CITY PLAN COMMISSION STAFF REPORT

November 1, 2022

Project Name
The Mabion

CD-CPC-2022-00165
Development Plan – Residential & Preliminary Plat

THE MABION
TREE PLAN

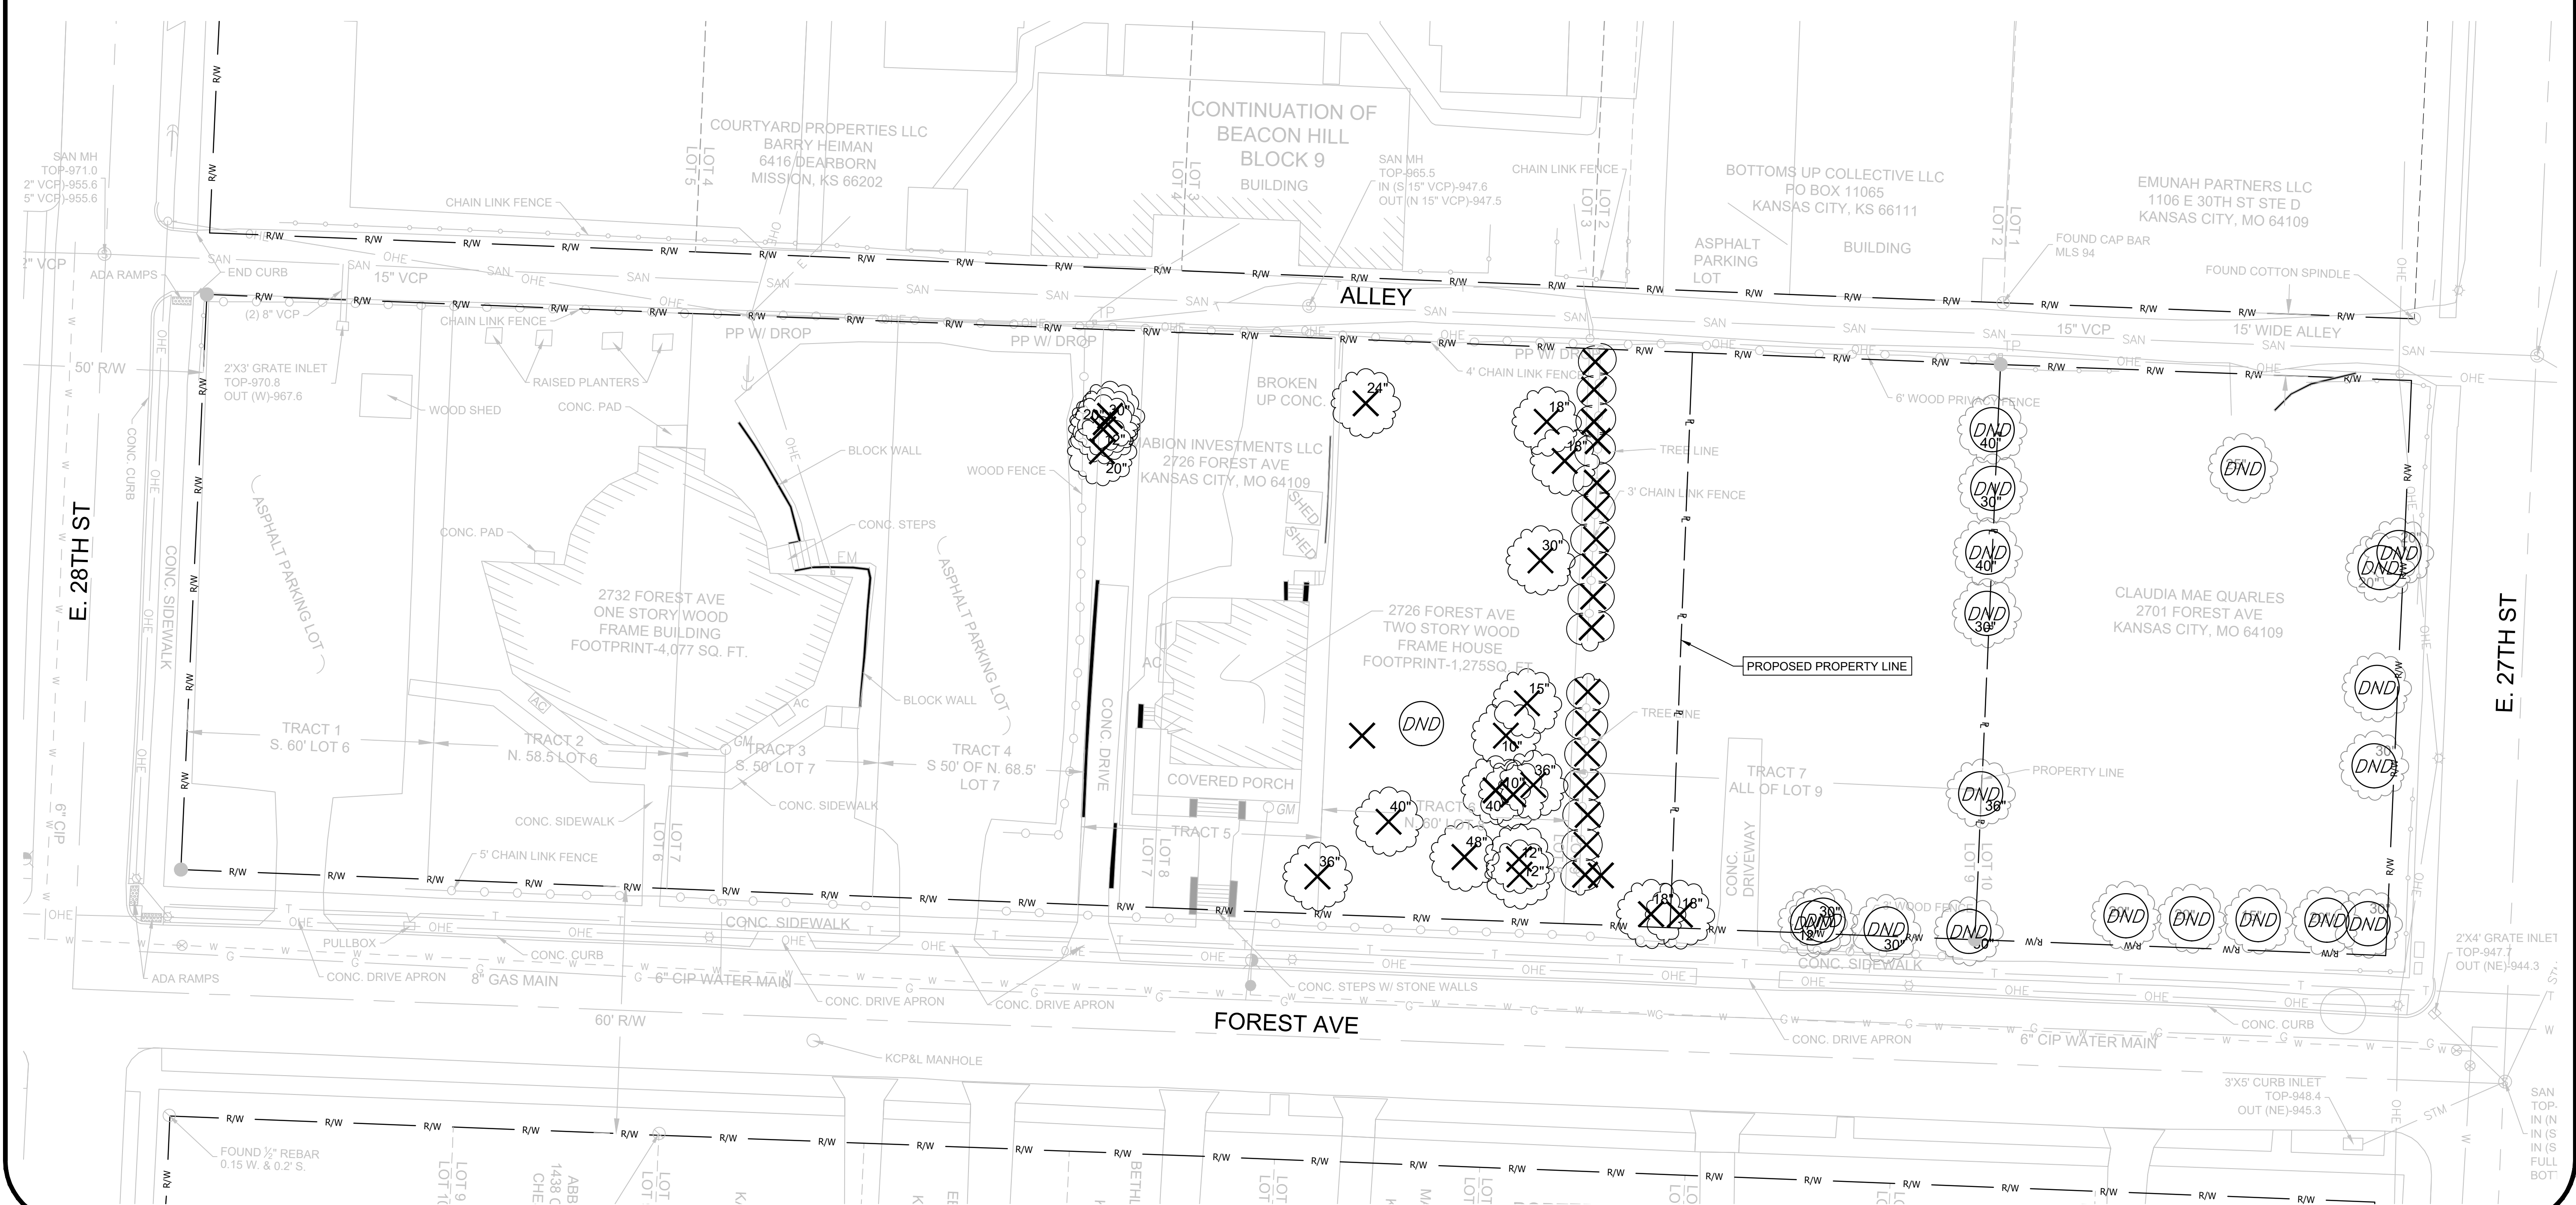
I. The plan must identify trees to be removed and trees to be preserved during the development of the subject property with the goal of saving trees that are not required to be removed for the development of the property.

The applicant provided a tree plan that identifies which existing trees will be removed or preserved.

1 NORTH ELEVATION
3/32" = 1'-0"

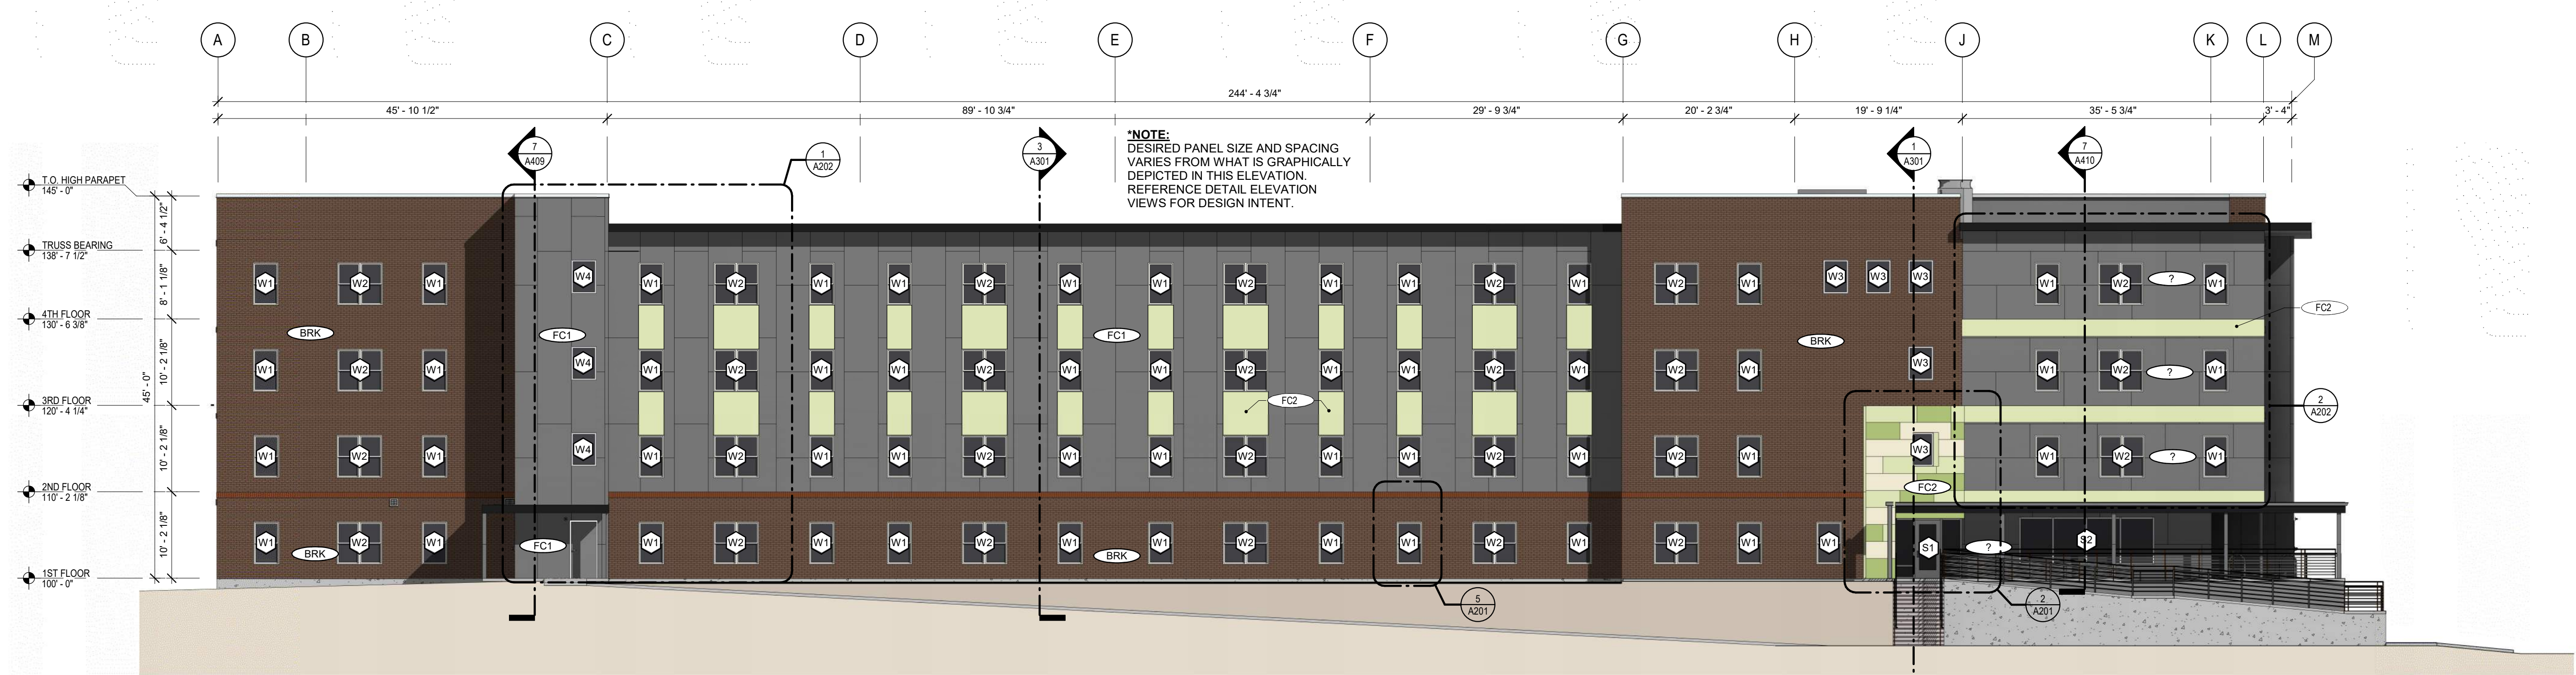
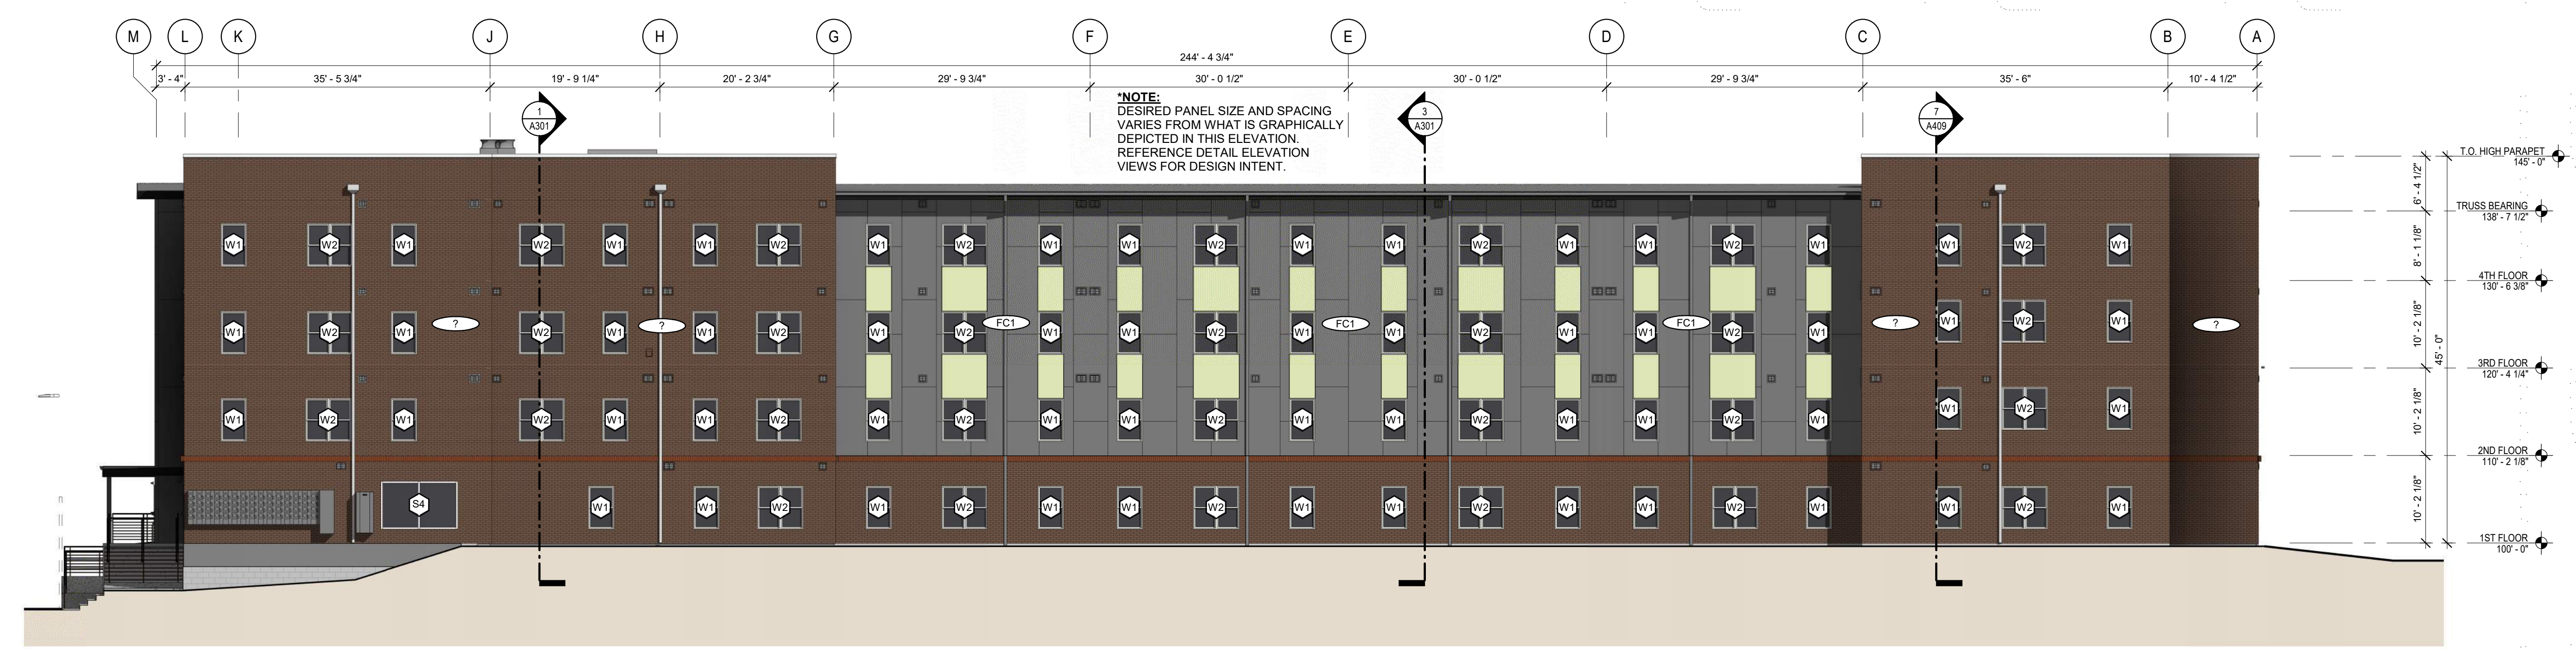
The architectural character of surrounding properties where The Mabion is proposed provide a wide variety of building types and materiality. Staff asked the applicant to incorporate more brick to complement the colonnades located on E. 28th Street. The applicant also incorporated windows on all four facades to complement the large windows found on the craftsmen style homes located on the east side of Forest Avenue. Staff was originally requesting balconies and walk up units to promote more "eyes on the street" and to allow for greater outdoor opportunities for residents of The Mabion. The applicant stated that due to the site topography, ADA standards and costs that they could not meet staff's request.

The orientation and setback of the proposed building allows for plenty of space between the structures located on Troost Avenue and on the east side of Forest Avenue. The building offers a mix of traditional and modern architectural materials. The applicant has worked with staff to provide more brick and enlarged the windows to complement the character of the surrounding area.

6. Applicant must pay application fee prior to submitting a response letter and moving to applicant DRC.
7. The applicant shall provide revised building elevations to City Planning and Development prior to ordinance request.
